REQUEST FOR PROPOSALS-Supplemental A

Department of Parks and Recreation Cricket Batting Cage Construction & Installation

Deadline for Submission EXTENDED: October 7, 2026, by 3:00 pm

APPENDIX A

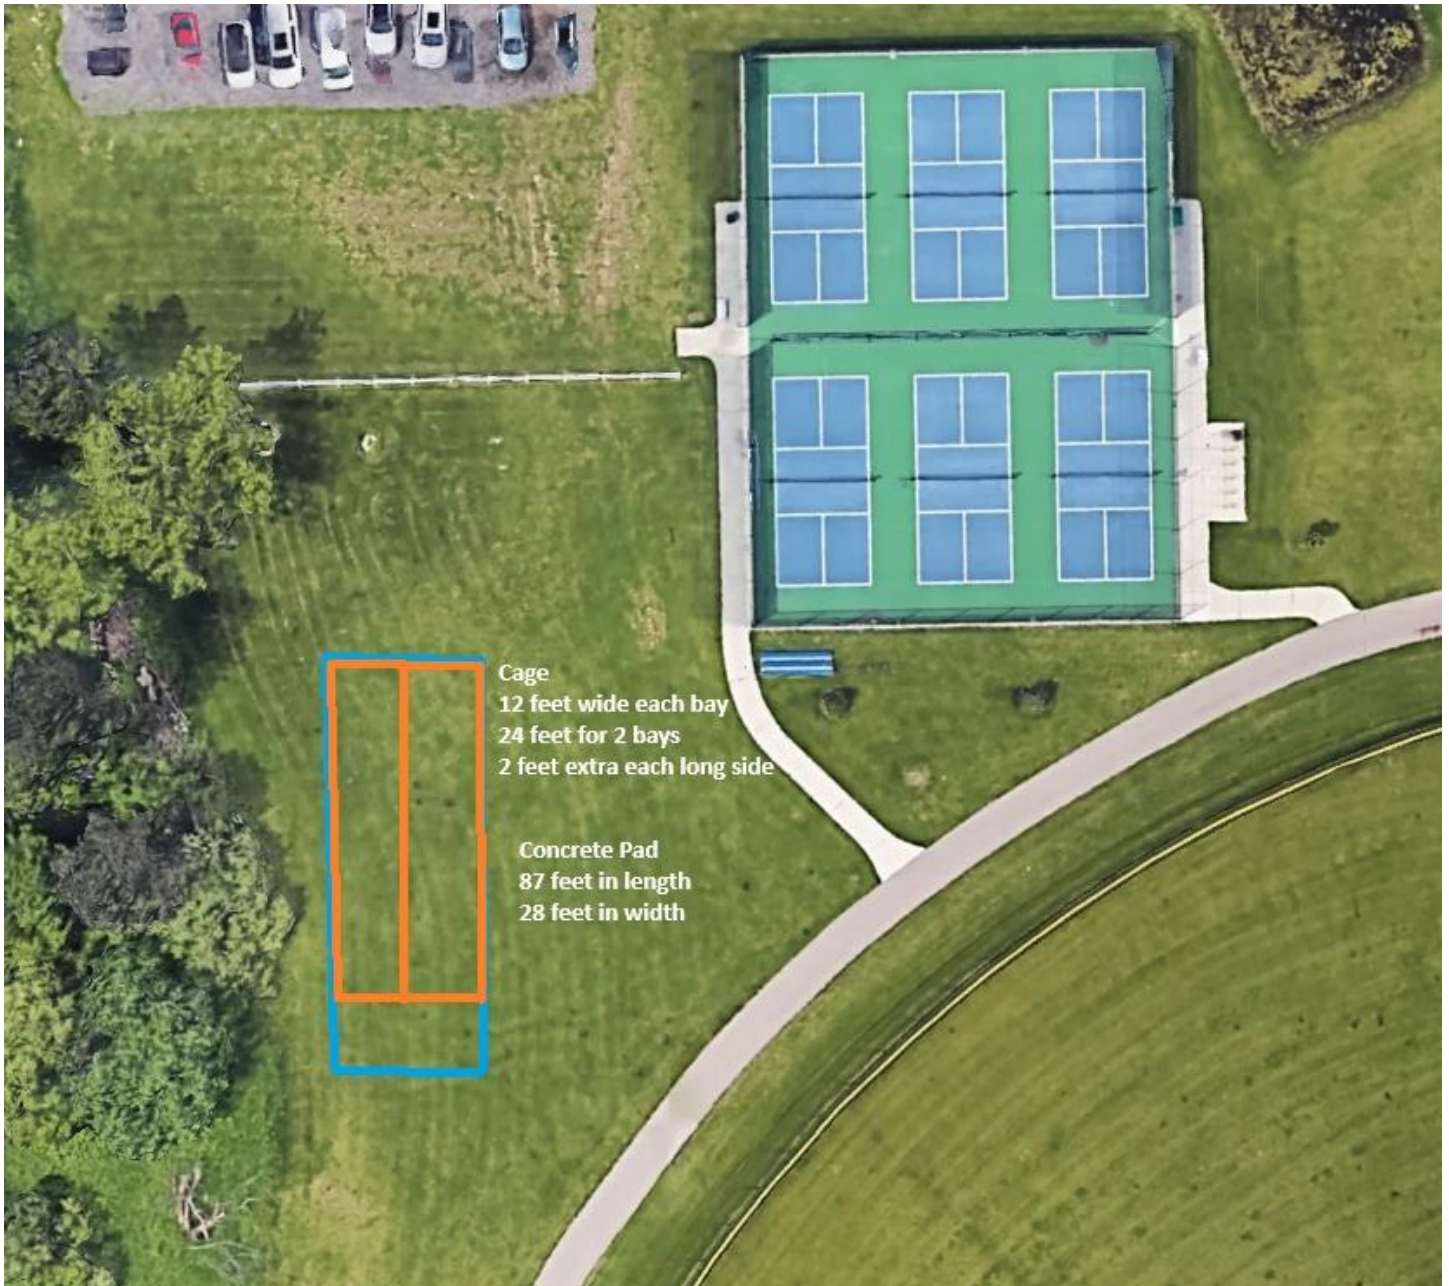
The location of the cricket batting cage will be at Towner Road Park (2055 Towner Rd., Haslett, MI 48840). The site location is proposed north of the baseball fields and west of the pickleball courts. The exact location will be determined during site visit prior to installation.

The dimensions are denoted on the photo.

Concrete Pad: 87x28 feet

Cage: 72x24x12 (two adjacent bays)
